UNITED STATES
DEPARTMENT OF THE INTERIOR
BUREAU OF LAND MANAGEMENTNMOCD
HobbsFORM APPROVED
OMB No. 1004-0137
Expires: July 31, 2010**SUNDRY NOTICES AND REPORTS ON WELLS**
*Do not use this form for proposals to drill or to re-enter an abandoned well. Use Form 3160-3 (APD) for such proposals.***SUBMIT IN TRIPLICATE – Other instructions on page 2**

El Zorro B Federal No. 001

30-041-20815

**El Zorro B Federal 1
30-041-20815
Energy Quest
February 29, 2016
Conditions of Approval**

Energy Quest
EL Zorro B Federal #1
30-041-20815
760 FSL + 560 FEL
27-T85-R36E
Roosevelt County

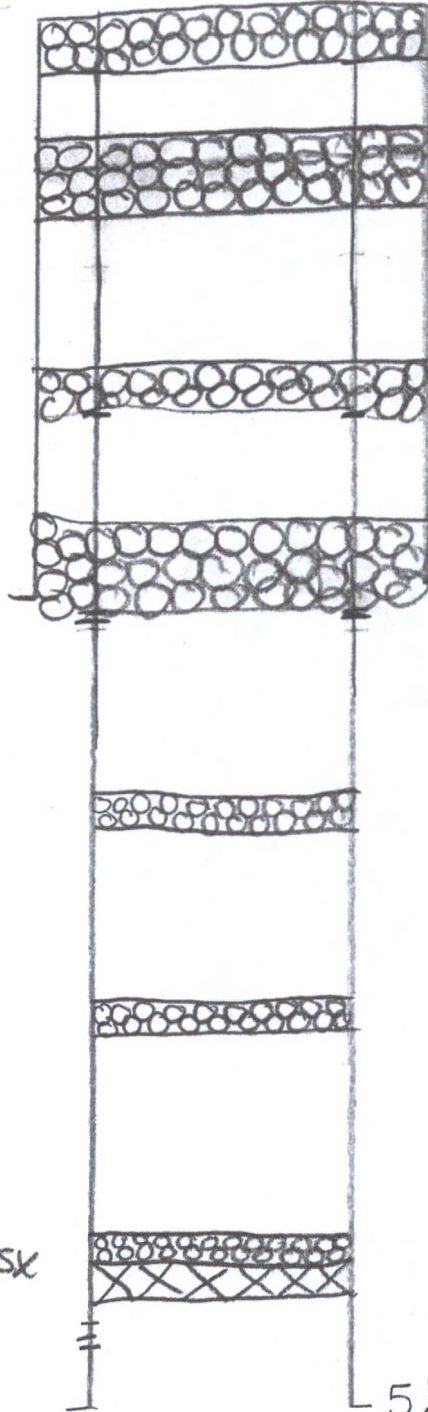
13 $\frac{3}{8}$ @ ~~350~~ 353' W/Cement Circulated

8 $\frac{5}{8}$ @ ~~4000~~ 4140' W/Cement Circulated

5 $\frac{1}{2}$ @ ~~9800~~ 9706' W/Cement Circulated

⑥ Perf + Sqz 75 sx @ 660-338 Tag (shoe) 300'

④ Perf + Sqz 65 sx @ 4050-3950 (Tag) 4190-4090'

① CIBP @ 9500 w/ 90 sx Perfs @ 9598-9612

5 1/2 @ 9706' W/TOC @ ±3500'

- 1. Operator shall place CIBP at 9,500 (50'-100' above top most perf) and place 20sx of Class H cement on top as proposed. WOC and TAG.**
- 2. Operator shall place a balanced Class H cement plug from 8,965'-8,765' as proposed. WOC and TAG.**
- 3. Operator shall place a balanced Class C cement plug from 5,950'-5,800' as proposed. WOC and TAG.**
- 4. Operator shall place a balanced Class C cement plug from 4,190'-4,090' to seal the 8-5/8" shoe as proposed. WOC and TAG required.**
- 5. Operator shall place a balanced Class C cement plug from 2,415'-2,215' to seal the Salt. WOC and TAG.**
- 6. Operator shall place a balanced Class C plug from 660'-300' to seal the 13-3/8" shoe. WOC and TAG.**
- 7. Operator shall place a balanced Class C cement plug from 60' - surface as proposed**
- 8. See Attached for general plugging stipulations.**
